PROJECT NO. B981

RE: RESPONSE TO CIVIL ENGINEERING ITEMS RAISED IN THE REQUEST FOR CLARIFICATION OF FURTHER INFORMATION IN RELATION TO PROPOSED TRANSITIONAL CARE FACILITY, COOKSTOWN INDUSTRIAL ESTATE (PLANNING REFERENCE: SD22A/0361)

Figure 1: Local Active Travel Schemes for Short Term Delivery/Recently Completed

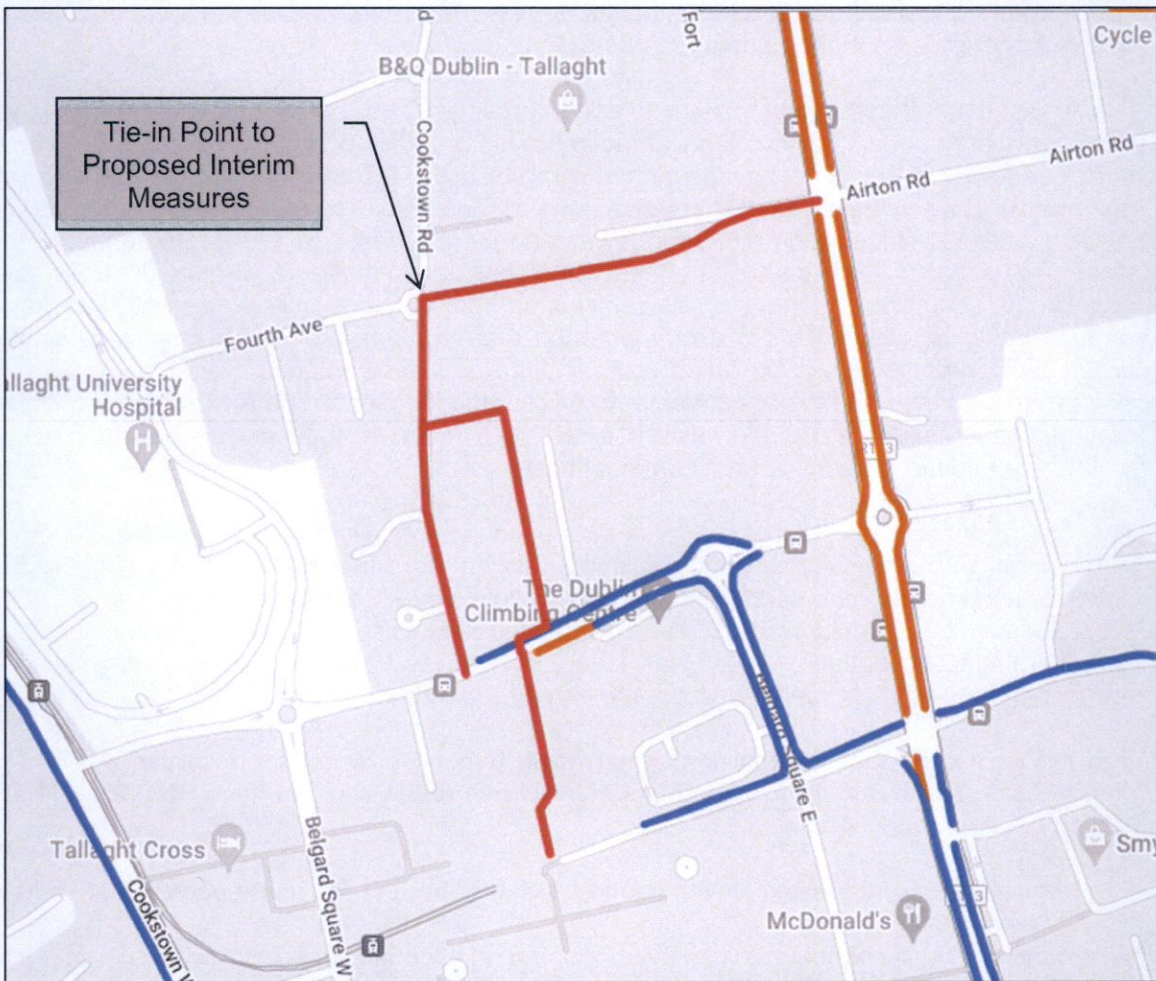
The LAP has a clear objective in relation to phasing and sequencing of development to ensure that isolated piecemeal pockets of land are not developed without connectivity and linkages. The applicant has proposed temporary pedestrian and cyclist upgrades from the site to Belgard Luas. The Planning Authority is very clear that temporary/interim works are not acceptable to the Council. A design team is being appointed by South Dublin County Council to provide a masterplan for Cookstown, focused on the public realm and to include pedestrian, cyclist and urban design upgrades. The applicant is requested to engage directly with the team appointed and ensure that a scheme of permanent works is agreed and provided, in tandem with the Cookstown masterplan, ensuring full integration of the proposed scheme and public realm works. The applicant may wish to apply for an extension of time in responding to this clarification of additional information request to enable this engagement. The applicant should also note that set down and loading areas outside the current site boundary along Cookstown Road and First Avenue on lands within the public realm and indicated for taking in charge by SDCC, will not be accepted irrespective of the ownership of same. In preparing a proposal for permanent works to be delivered, the applicant should incorporate all relevant items of concern raised in the Stage 1 & 2 Road Safety Audit and ensure public lighting is provided to the satisfaction of the Public Lighting Section. In preparing this response, the applicant should engage with all relevant sections of the Local Authority, and other relevant bodies, to ensure the proposed works will be acceptable prior to submission.

- The recently construction Belgard Square North Link Road which ties into the proposed measures directly linking to the town centre;
- The Tallaght Public Realm and Plaza which is at construction stage which will link with the Belgard Square North Link Road and further enhance accessibility;
- The Airtion Road Extension which received Part 8 approval in 2022 and is at detailed design stage, with an estimated 2 year delivery programme which will also link with the proposed interim measures and improve accessibility to the wider area via Belgard Road.

The aforementioned are highlighted further in the below mapping showing the active travel routes which have been recently completed or are to be delivered in the next 2 years (shown in red) along with the existing cycle routes in the area.
